कार्यालय अधिकारी अभियन्ता  
निर्माण खण्ड लोक निर्माण विभाग-ऊर्खीमठ (रुद्रप्रयाग)  
Office of the Executive Engineer, C.D, P.W.D. Ukhimath

विषय:- भारत सरकार द्वारा खण्ड के अन्तर्गत ऑनलाईन अपलोड वनभूमि हस्तान्तरण प्रस्ताव संख्या FP/UK/ROAD/15603/2015 पर लगाई गयी आपतियों के निराकरण के सम्बन्ध में।

जियोरेफरेन्स मैप— जनपद रुद्रप्रयाग में राज्य योजना के अन्तर्गत भटवाड़ी – सुनार – चन्द्रापुरी मार्ग के निर्माण हेतु

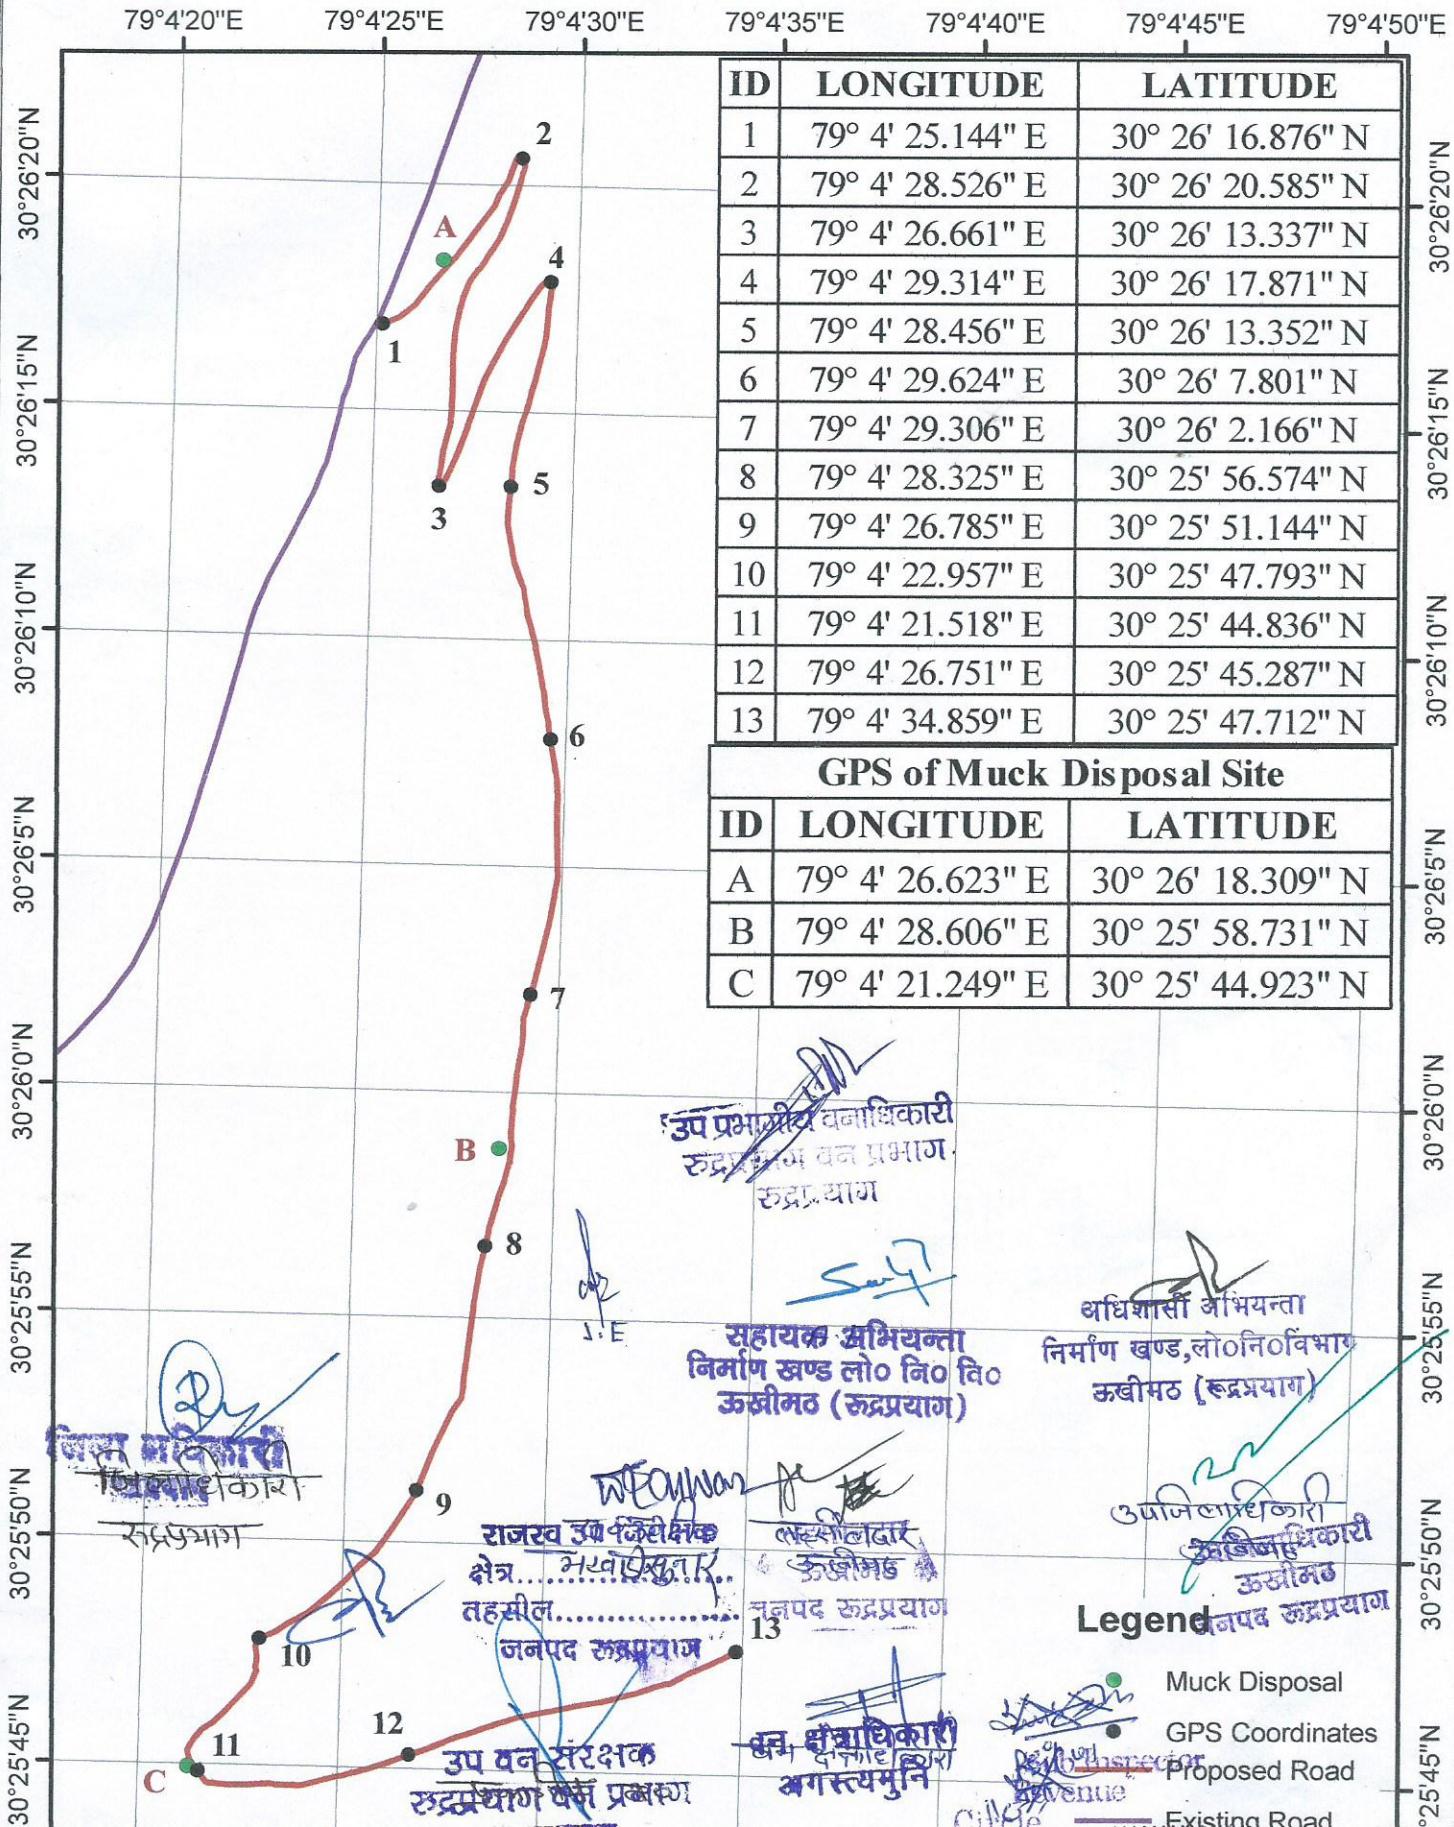
6	May provide/ upload scsnnd copy of GIS software generated geo referenced digital map showing geo coordinates at 200 to 300 m interval along the alignment of the proposed road including all turning points (.TIFF,.IMG or .JPEG). Thereafter, this map only may be uploaded as KML file in C (b) Part I .	Crrection have been made in C of form-A, Part-I
7	The area proposed for diversion is 0.612 ha but the area mentioned in FRA certificate and in all but the area mentioned in FRA certificate and all in its annexure is 0.525 ha. The state Govt may correct the area in FRA certificate and in all its annexure and submit / upload revised FRA.	Crrection have been made in K of form-A, Part-I
8	As mentioned in the land schedule uploaded in part I. as an additional document the area prposed	Crrection to be made by DFO office
